08-Apr-2025 - Redlines - DD

PLAN 1
The Clayton - LH
'CRAFTSMAN'
ELEVATION

THE CLAYTON - LH

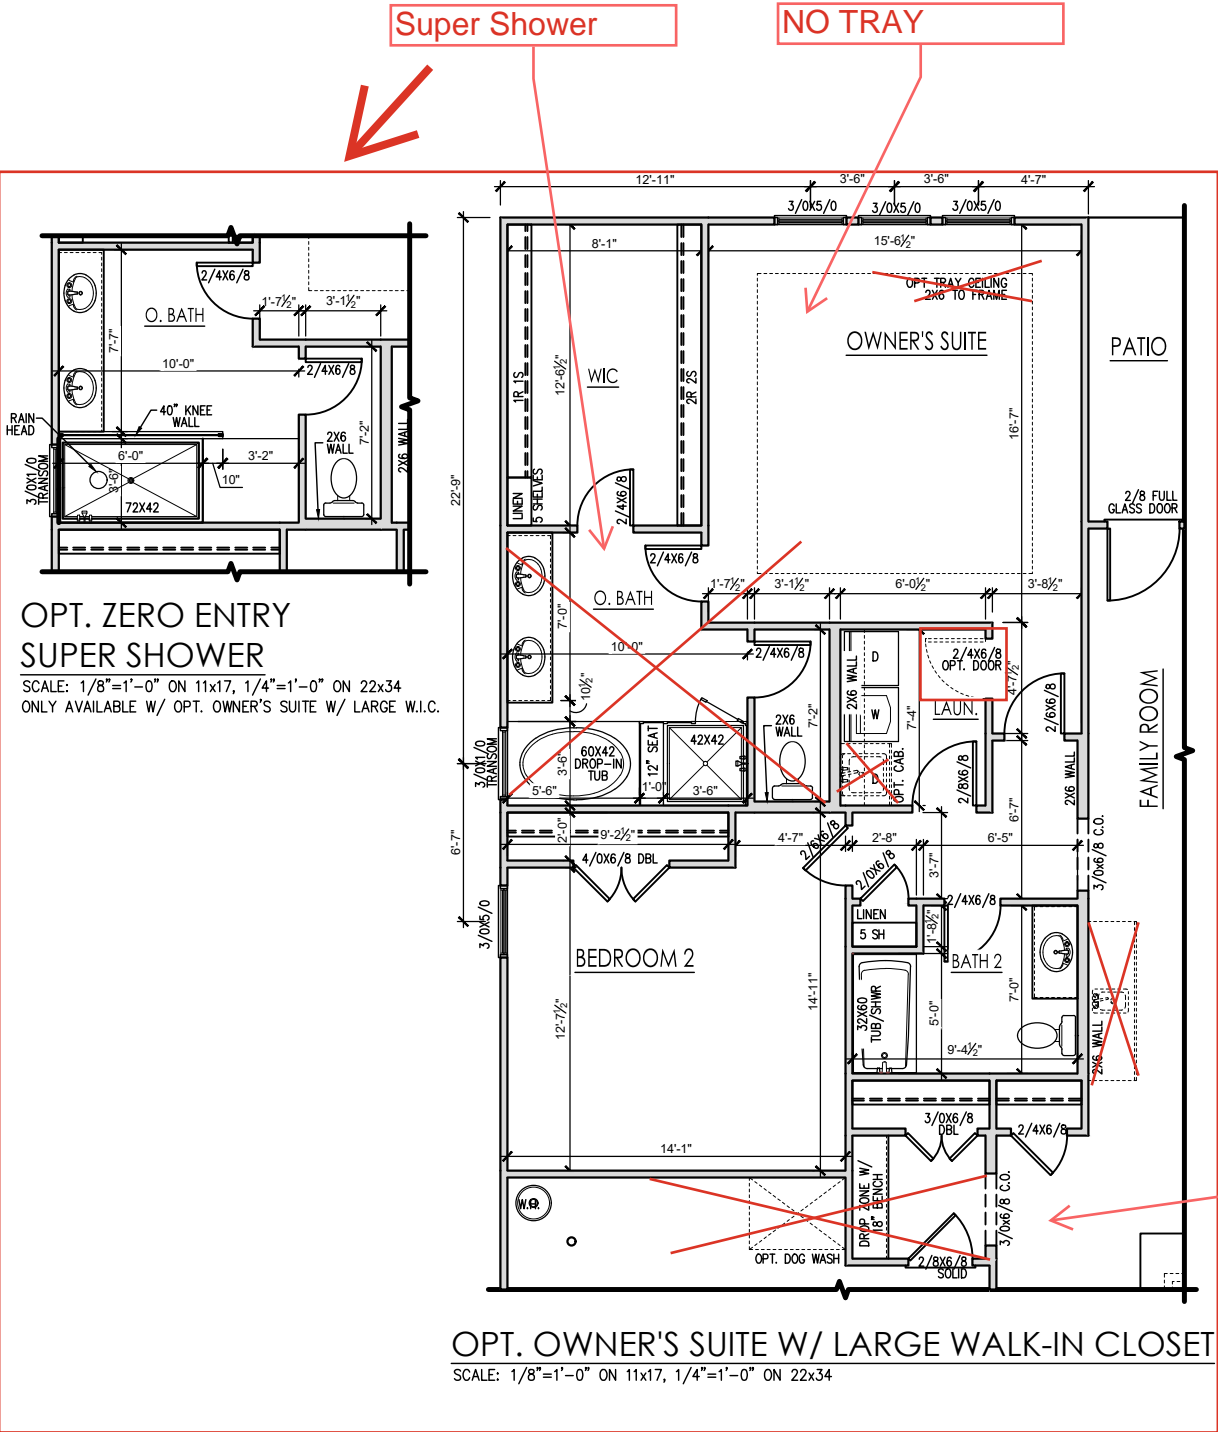
Floor plan of the Family Room and Patio/Deck area. The Family Room is 12'-8" wide and 10'-8" deep. It features a fireplace, a 2/8 full glass door leading to the patio, and a 3/0x5/0 opening. The Patio/Deck is 15'-6" wide and 10'-8" deep. Dimensions for the patio area are: 5'-1", 5'-0", 5'-5", 2'-3 1/2", 2'-9 1/2", 2'-11", and 2'-6". A red arrow points to the patio area.

Floor plan of the second floor showing Bedroom 3, Bath 2, and a linen closet. The plan includes dimensions for walls, doors, and windows. A red 'X' is drawn across the plan, indicating a proposed change. A note "OPT. REV. CENTER" is present near the bathroom. A note "W.H." is near the dog wash area.
